# CITY OF ALBUQUERQUE

**RE: Broadstone Highlands Hotel Block- Springhill Suites  
Central and Mulberry NE  
Grading and Drainage Plan  
Engineer's Stamp Date: 6/18/18  
Hydrology File: K15D034B**

Re: Broadstone Highlands Hotel Block / Hydrology File K15D034B

GRADING &  
DRAINAGE PLAN

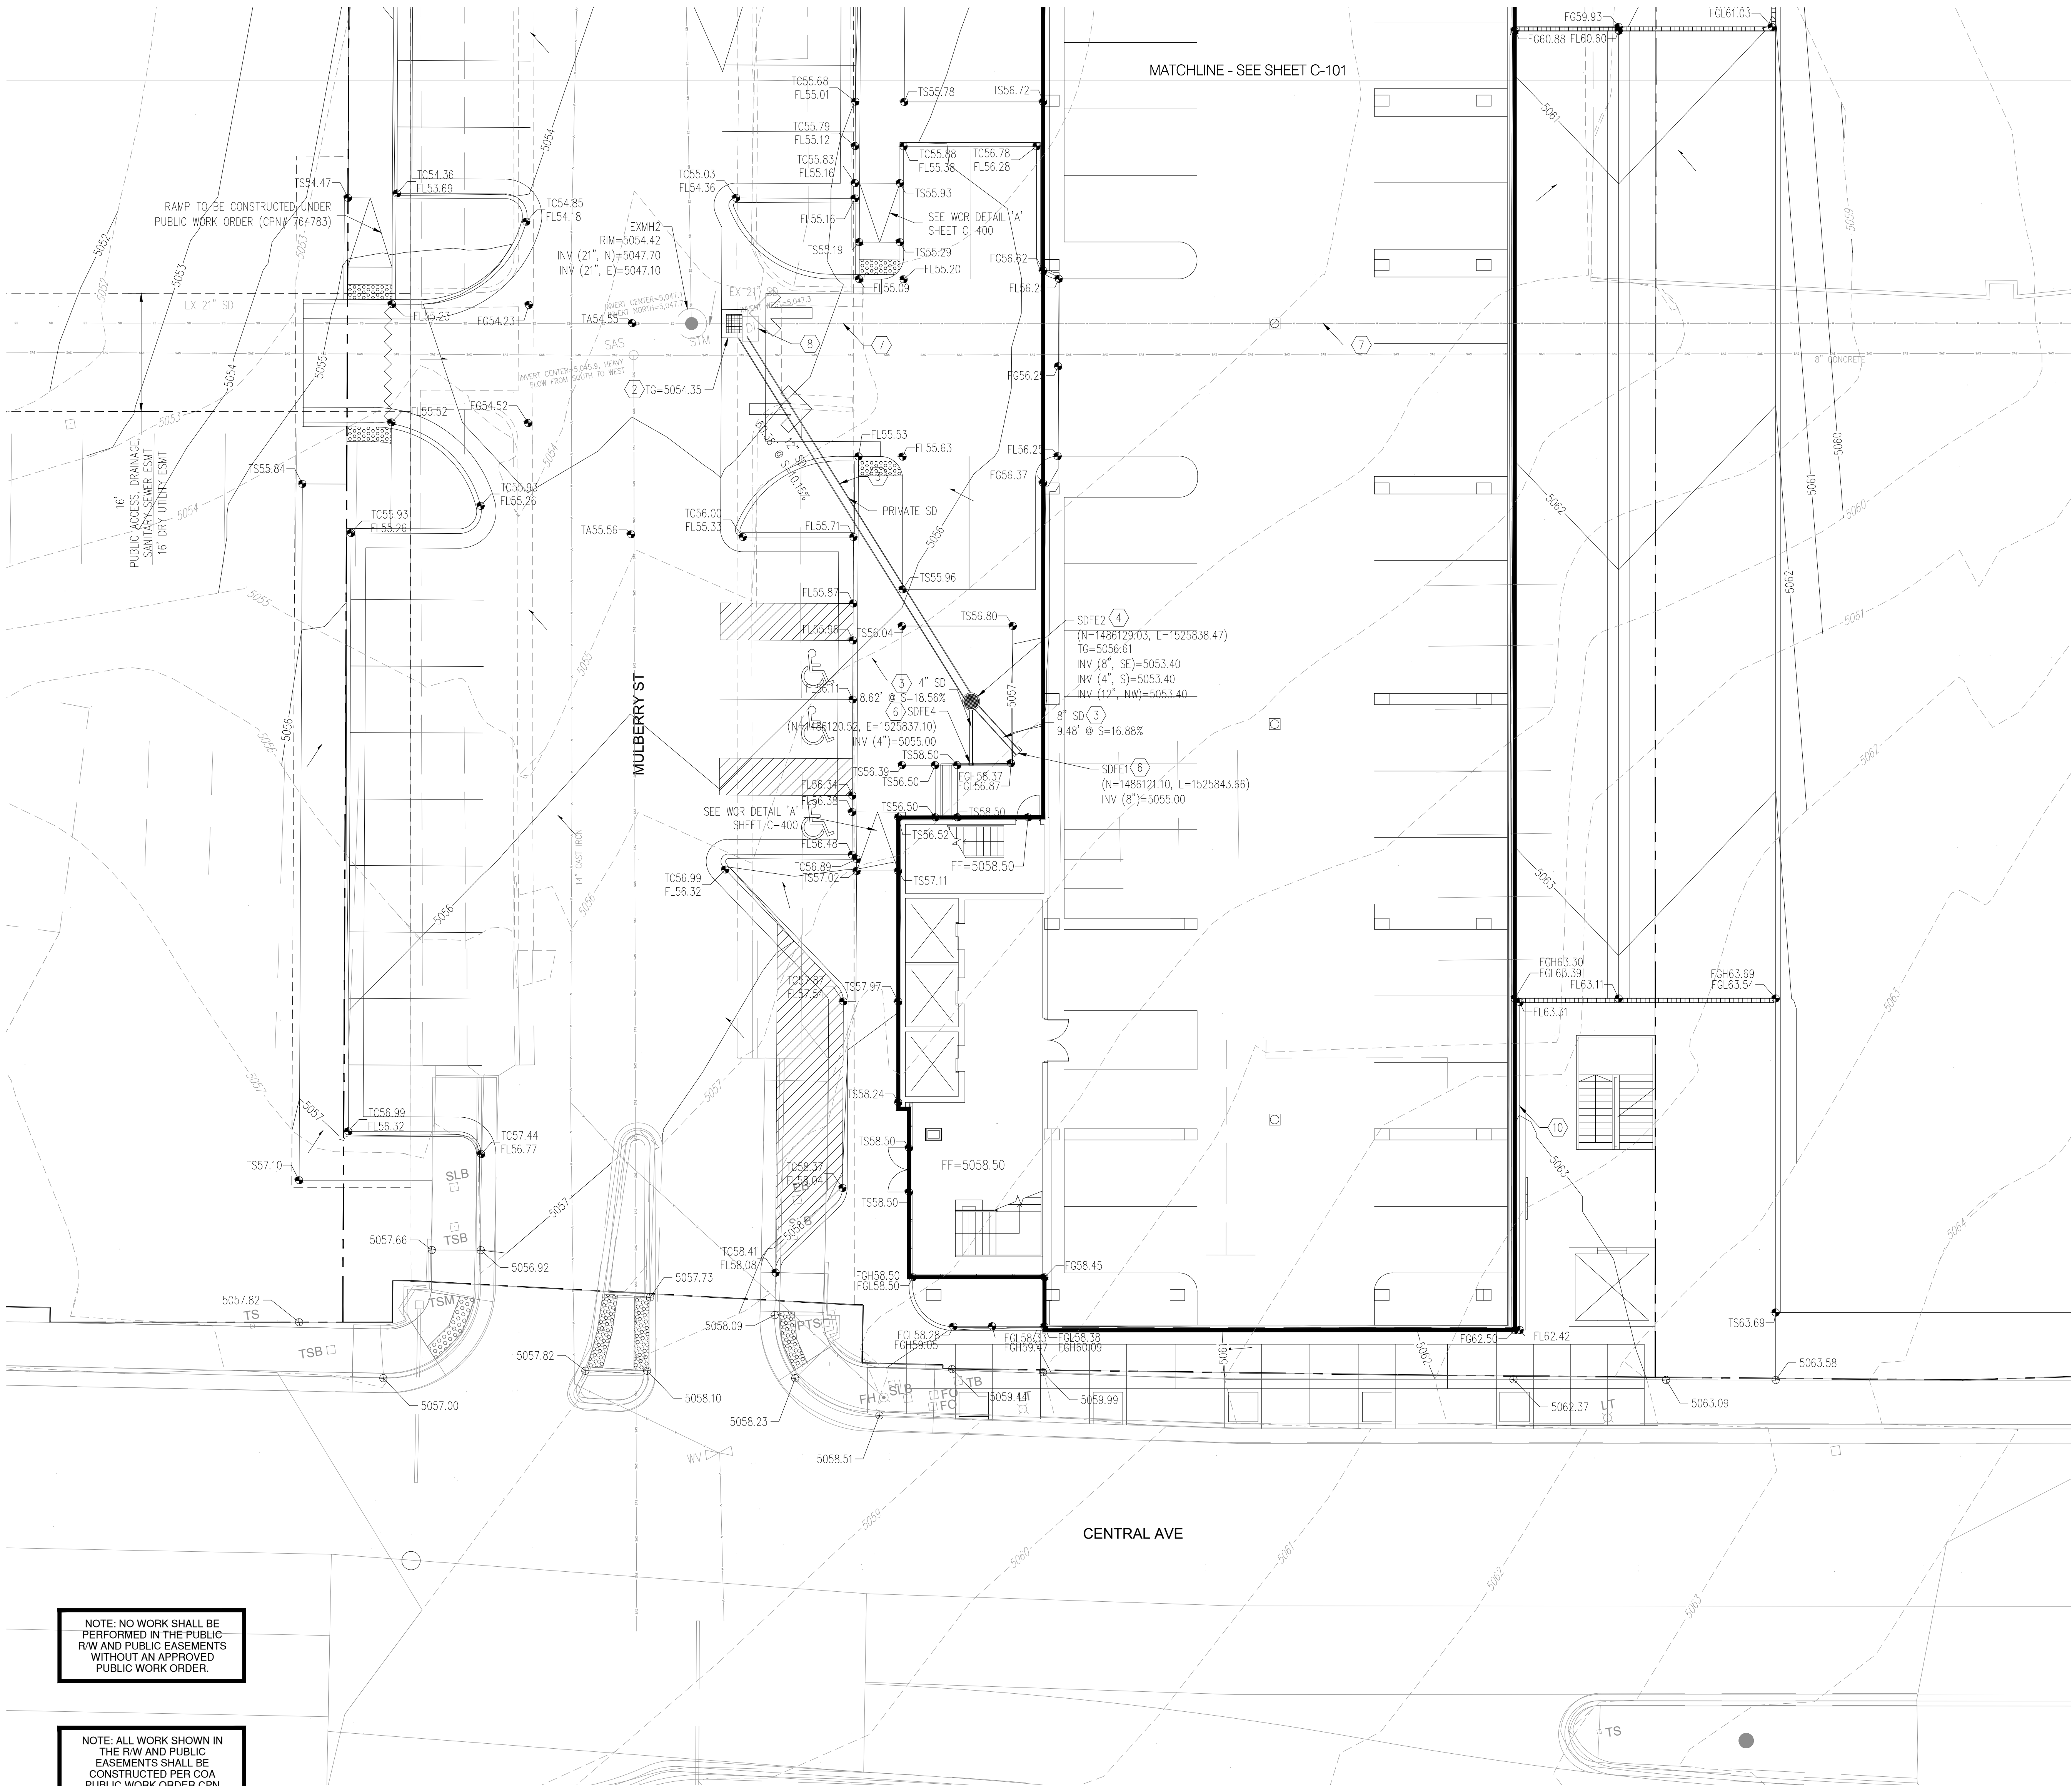
3. The 18" HDPE penetration into the new (public?) type-A inlet cannot be accepted. This will either need to be RCP, or be 12" or less and piped into back on inlet, similar to std dwg 2237.

4. Provide valley gutter across the drive entrance on Copper and across the intersection of Copper and Mulberry.

5. Provide alley gutter along Mulberry, between the east parking and the drive aisle, where the drainage will concentrate.

6. Clarify how standing water will be prevented in the NW corners of the west parking along Mulberry. Curb cuts that allow water to drain across the sidewalk are not acceptable.

*Response: Noted. The pipe to be accepted by the public inlet will be 18" RCP, not HDPE.*

*Response: A valley gutter has been added to the drive entrance along Copper and to the intersection of Copper and Mulberry.*

*Response: A valley gutter has been provided at the entrance into the parking garage where flow will concentrate.*

*Response: A slope label has been added to the grading plan to indicate that the grades are to convey a slope of 0.50% to get the drainage back into Mulberry St. A curb cut has been added next to the ramp so that excess flow can be captured in the landscape island and later discharged through the other curb cut so that it does not drain across the proposed sidewalk.*

**PROPOSED STREET SECTIONS**

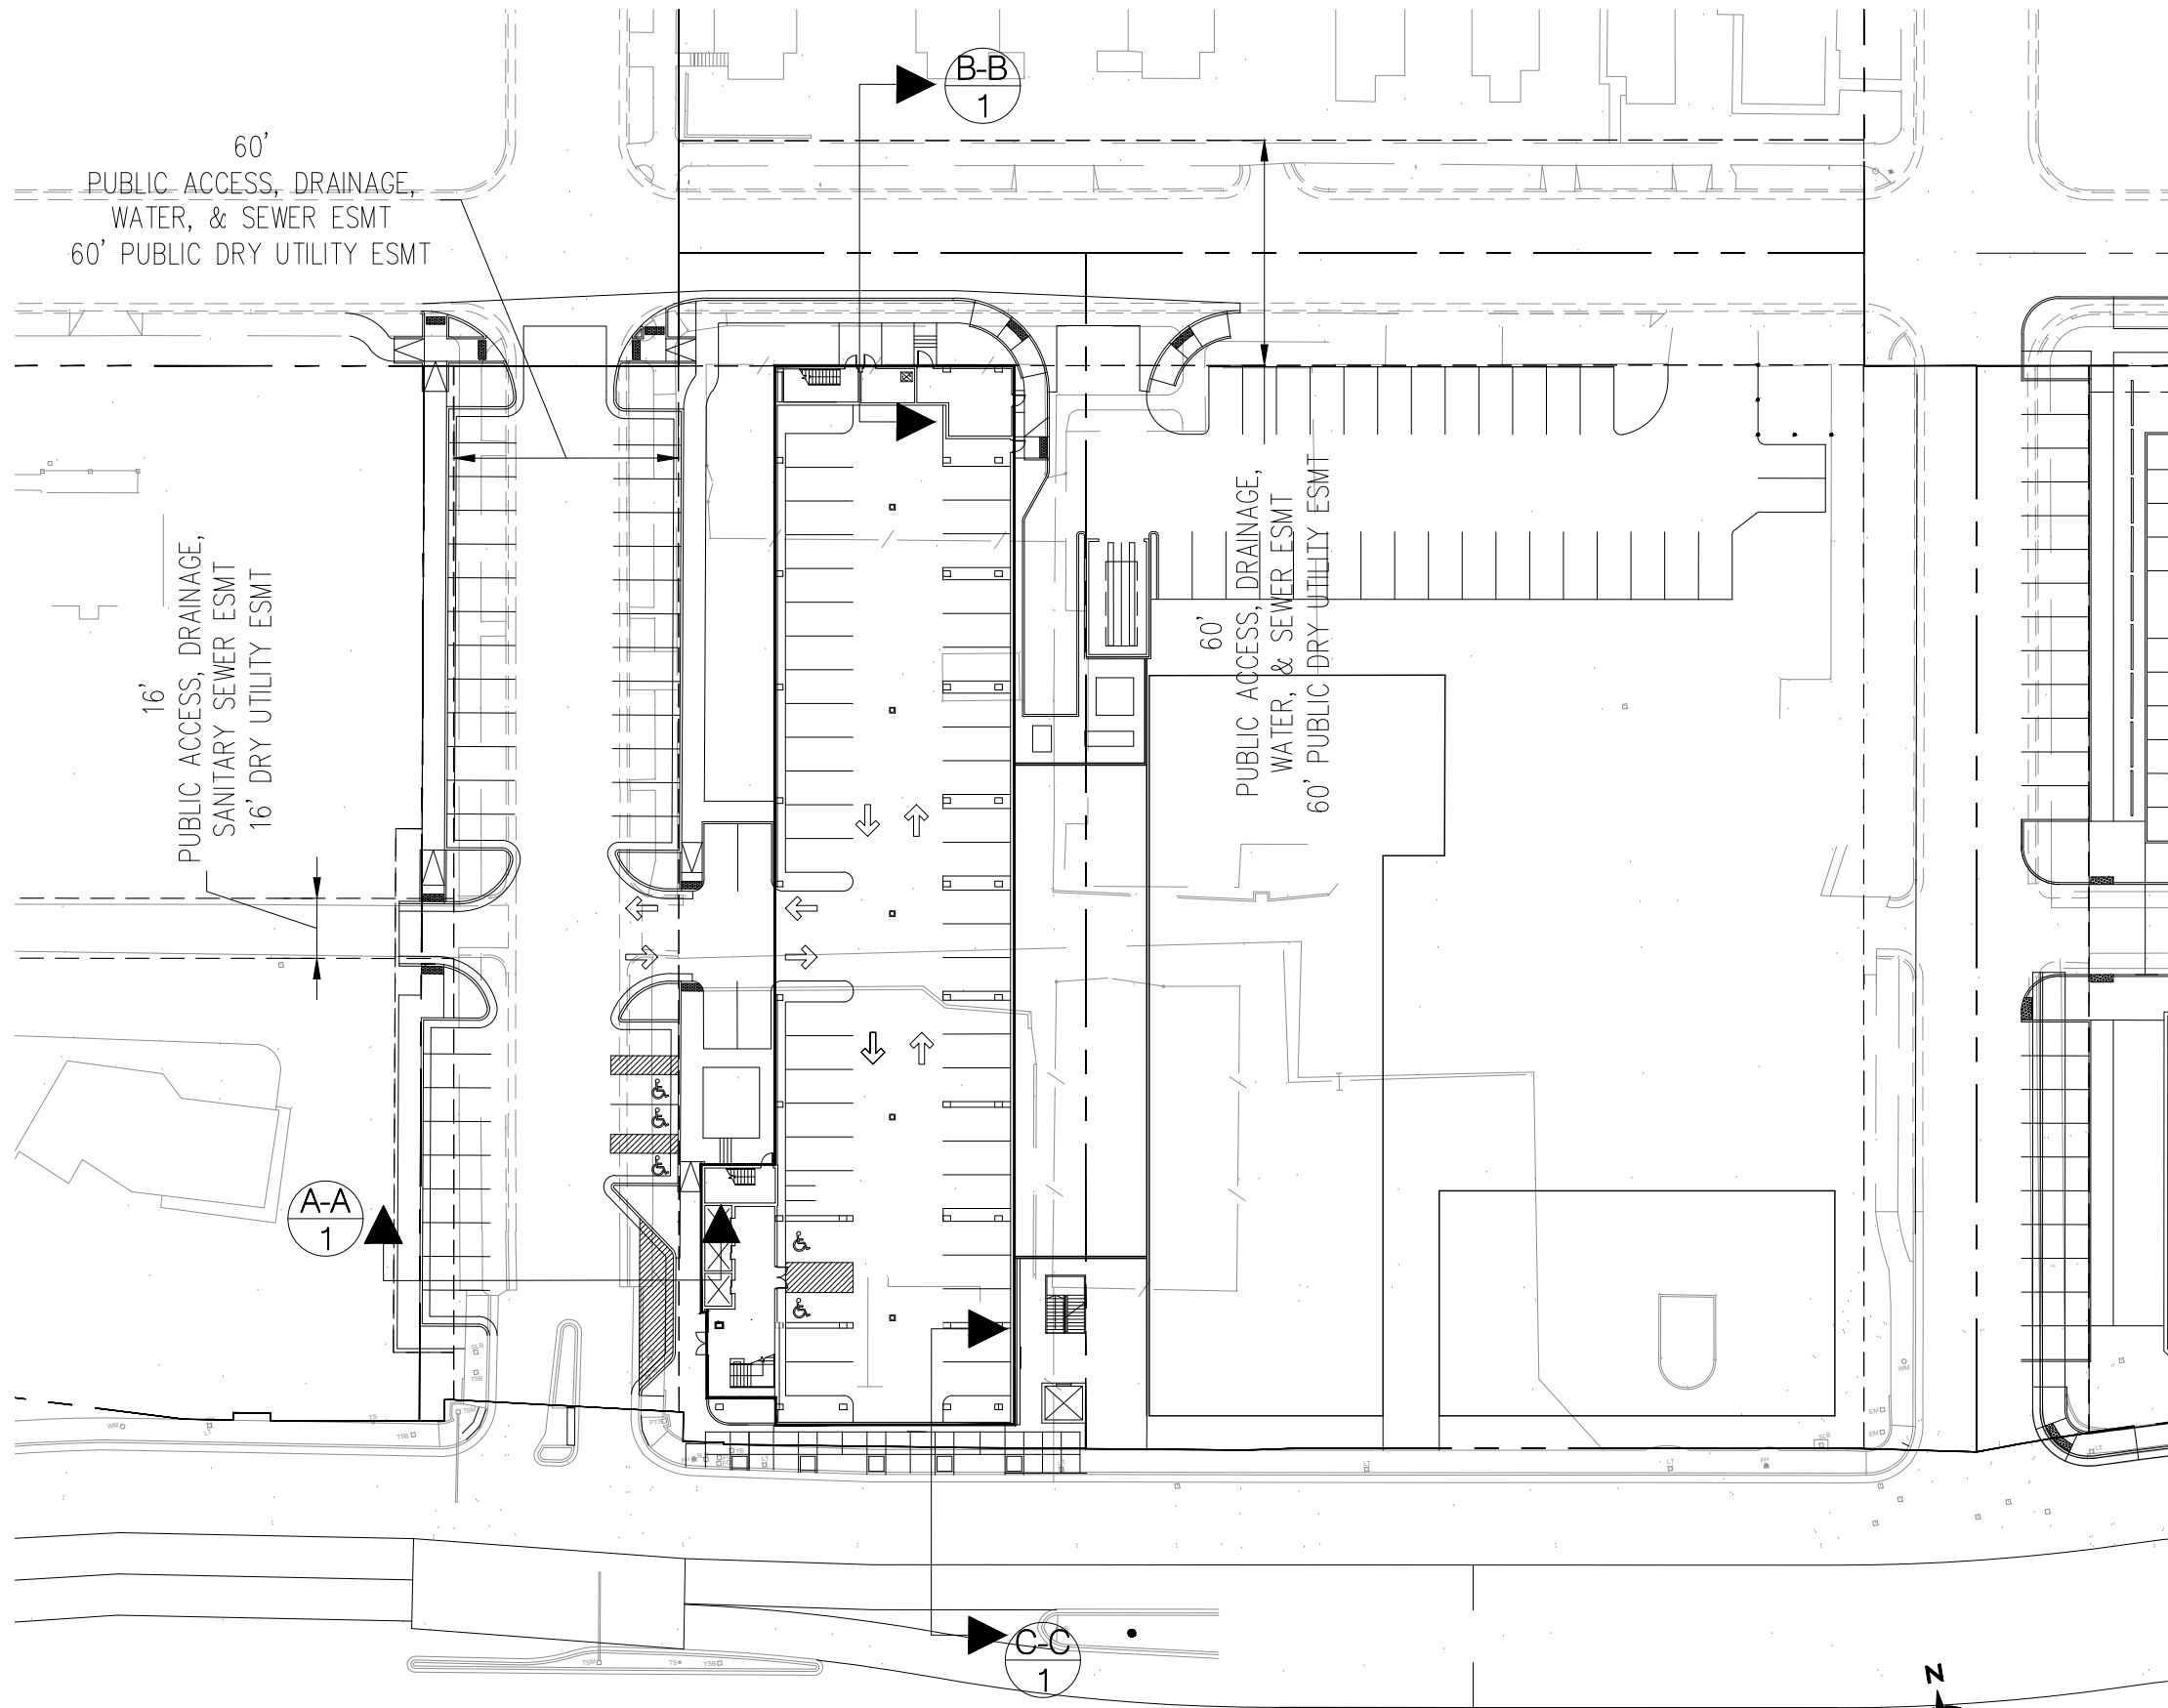
7. Provide sections of the proposed retaining walls/stem walls and show the property line, existing and proposed grades on the section views. In accordance with DPM Ch.22, section 5 part B, grading and wall construction near the property line may not endanger adjacent property or constrain its use.

8. Depending on the above potential conflicts, the following will be required:
- a. Any private encroachment into the public ROW by the footer, retaining wall or any structure will require a revocable permit.
  - b. Any private encroachment into public easements by the footer, retaining wall or any structure will require an encroachment agreement.

*Response: Please see the attached exhibit, "Highlands Hotel, Proposed Street Sections".*

*Response: Noted. The foundation along Copper Ave will require an encroachment agreement. The sections along Mulberry St and Central Ave will not require any permit or agreement per the provided exhibit.*
